UNITED STATES PATENT AND TRADEMARK OFFICE

APPLICATION NO.	FILING DATE	FIRST NAMED INVENTOR	ATTORNEY DOCKET NO.	CONFIRMATION NO.
10/692,613	10/24/2003	Mark A. Francis	K-2043	8816
27877	7590	12/30/2005	EXAMINER	
KENNAMETAL INC. P.O. BOX 231 1600 TECHNOLOGY WAY LATROBE, PA 15650			ADDISU, SARA	
			ART UNIT	PAPER NUMBER
			3722

Office Action Summary

DETAILED ACTION***Drawings***

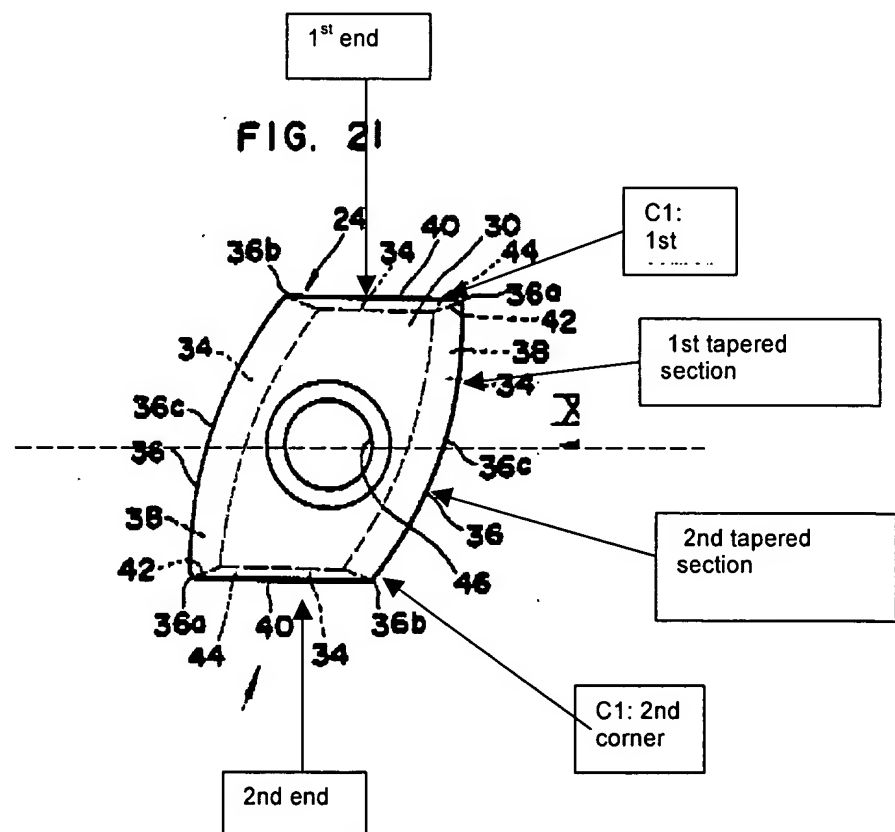
1. Claims 17, 27 and 37 are rejected under 35 U.S.C. 102(b) as being anticipated by Shimomura et al. (USP 4,714,383), or, in the alternative, under 35 U.S.C. 103(a) as obvious over Shimomura et al. (USP 4,714,383).

SHIMOMURA ET AL. teaches a rotary cutting tool (10c) including a body having a rotational central axis, plurality of adjacent flutes (first and second) (20c) formed in said body (12c) and including adjacent insert receiving pockets (22c) (first and second

FIG. 35

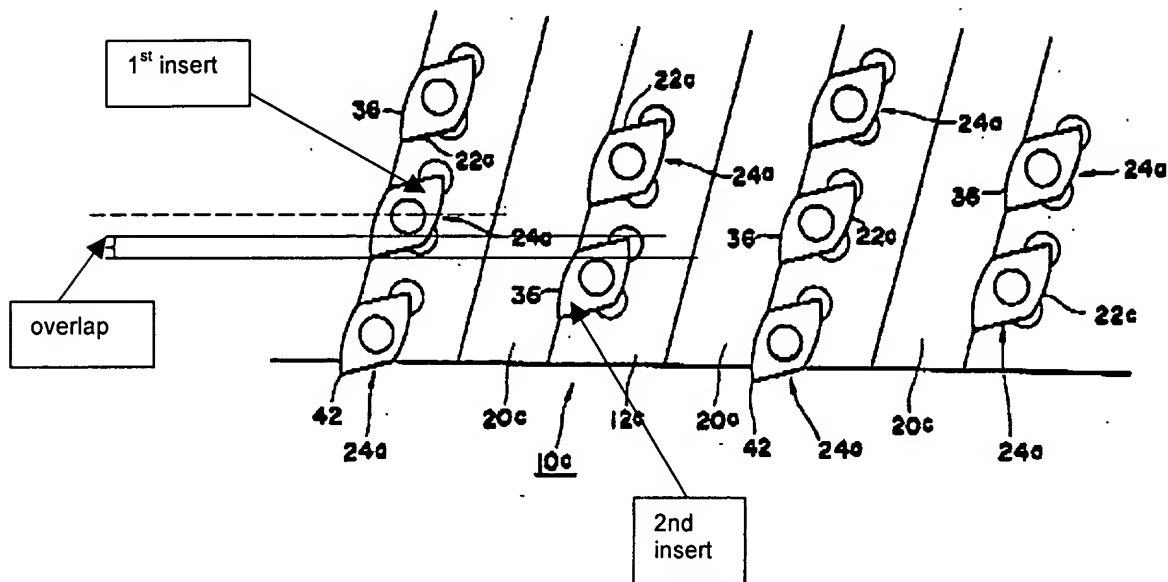
insert receiving pockets) with inserts (24a) mounted in them ('383, figure 3 and Col. 8, lines 47-60). SHIMOMURA ET AL. also teaches each cutting insert (24a) having a first end, a second end, a centerline (CT) disposed midway between the first and second ends, a tapered cutting edge (36) spanning between the first and the second end, a first corner (c1) formed at the juncture of the tapered cutting edge and the first end and a second corner (c2) formed at the juncture of the tapered cutting edge and the second end (see figure below).

Regarding claims 18, 28 and 38, SHIMOMURA ET AL. discloses the centerline of the first insert and the end of the second insert overlapping (see figure below).

Regarding claims 20-23, 30-33, 40-42, SHIMOMURA ET AL. teaches in figure 35, cutting edges (36) parallel to each other. Additionally, the tapered cutting edge (36) of the insert is defined by a first and second tapered section, forming a convex curve configuration of a constant radius (see figure below). Regarding claims 24, 25, 34, 35, 43 and 44, although SHIMOMURA ET AL. is silent about the first and second flutes and insert receiving pockets being helically arranged, SHIMOMURA ET AL. teaches in figure 35, the cutting edge of each insert being axially spaced apart from the cutting edge of the next adjacent insert and the inserts in each flute are staggered such that two or more rows are necessary to produce one complete or "all effective" cutting edge therefore they are helically arranged. This insert/flute arrangement for a conventional helical mill is evidenced by DEROCHE ET AL. ('811, Col. 1, lines 14-15 and 18-23).

Regarding claims, 19, 29 and 39, SHIMOMURA ET AL. discloses the claimed invention, i.e. the first and second inserts overlapping (see figure below) except for the centerline of the first insert overlapping the first end of the second insert by more than half the
